DESIGN REVIEW TEAM (DRT) COMMENTS

Planning Area: Uptown Urban Village: Illustrations of Design Standards | Rev. 04/16/2025

CASE NUMBER:	UDP-DRT24004	NOTES: <ul style="list-style-type: none">Principles in bold are dimensional standards required by Code (ULDR) Section 47-37B.Principles marked "yes" / "no" indicate if project meets intent of guidelineN/A = Not applicable; more information needed means there is insufficient information to review.
PROJECT NAME:	Cypress Multifamily	
PROJECT ADDRESS:	150 NW 68 th Street	
REVIEW DATE:		
CASE PLANNER:	Jim Hetzel	
CONTACT INFORMATION:

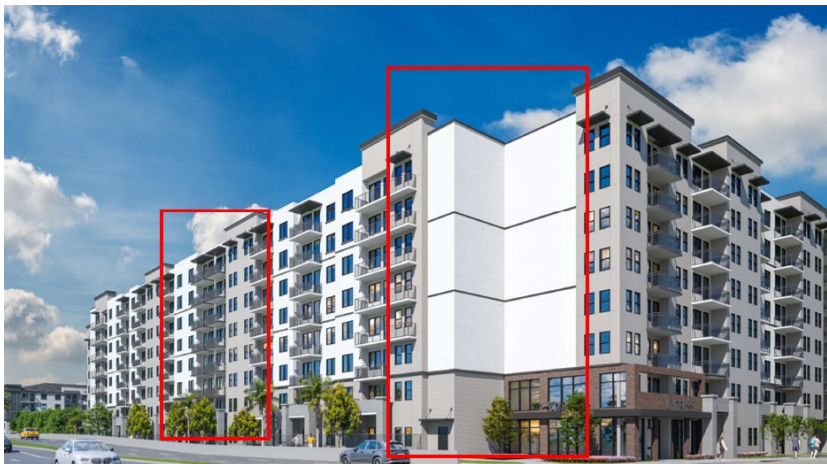
CITY REVIEW COMMENT: DRT reviewed this deviation and determined it DOES NOT meet the design intent. In order to address the design intent, the DRT recommends the following:

The buildings facing Andrews should contain more bay window style, additional Bahama shutters, and the ground level units have direct access to the sidewalk, which may be gated for security.

The front elevations facing the street shall contain the same bay window style that is on the rear elevation replacing a minimum of 50% of the windows to bay windows with projecting awning above to animate the elevation and reduce heat gain.

The building frontage does not provide enough articulation combined with the deviation to the height and deviation to the setback, the building looms over McNab. A significant articulated area needs to be provided along the frontage perhaps in the middle.

The building corners shall be architecturally enhanced replacing the blank wall areas. Enhancements shall include both horizontal and vertical design solutions that address the visual aesthetics of the corner. Below is snapshot of the building regarding these issues.
